MILITARY SPECIFICATION

DIMMER, LAMP, 60 WATT, 120 VOLT,

MEDIUM SCREW BASE AND SOCKET

This amendment forms a part of Military Specification MIL-D-12313C(ME), dated 17 June 1971, and is approved for use by all Departments and Agencies of the Department of Defense.

FIGURE 2. RESISTOR

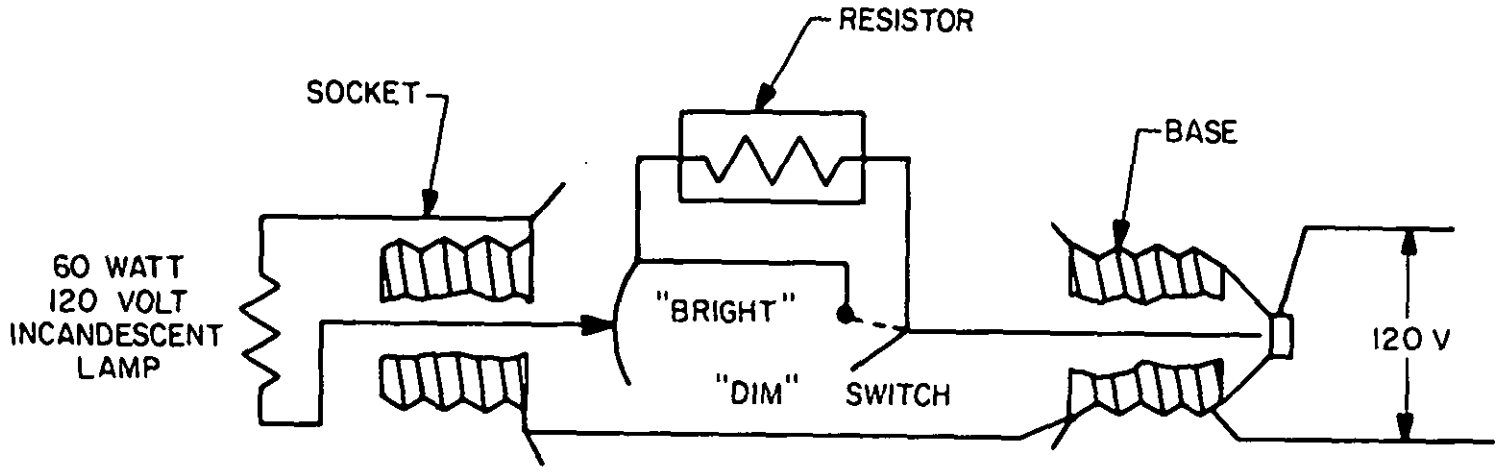
3.4.1 Resistor. When a resistor is furnished, the resistor shall be wire wound, vitreous enamel covered, 300 ohms, plus or minus 15 percent. The resistor shall be wired in series with the base and socket as shown in Figure 2.

3.5.1 Resistor dimming device. When used with a resistor type dimming device (see 3.4.1), the switch shall be a single-pole, single-throw type. In the 'dim' position the switch contacts shall be open; in the 'bright' position, the switch contacts shall be closed (see Figure 2).

FIGURE 3. AUTOTRANSFORMER

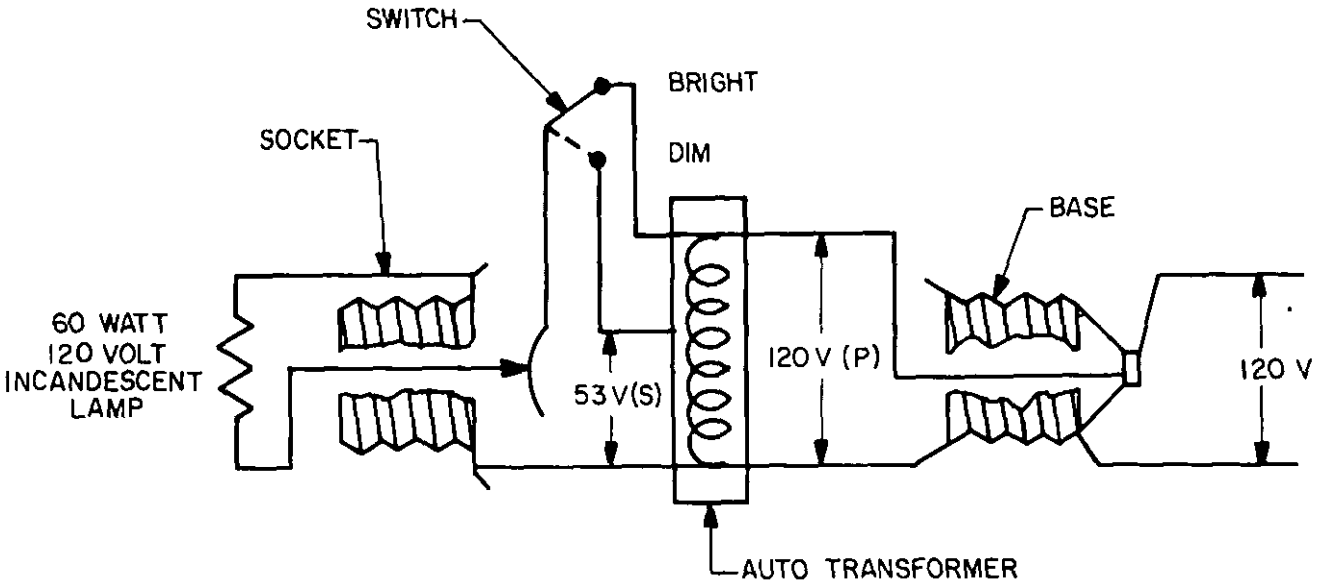
3.4.2 Auto transformer. When an auto transformer is furnished, the auto transformer shall convert power from 120 volts to 53 volts at the socket of the dimmer. The auto transformer shall be wired as shown on Figure 3."

3.5.2 Auto transformer dimming device. When used with an auto transformer dimming device (see 3.4.2), the switch shall be single-pole, double-throw. In the 'dim' position the switch shall complete the circuit from dimmer base to socket which includes the auto transformer; in the 'bright' position the switch shall make a direct connection between the dimmer base and socket (see Figure 3)."
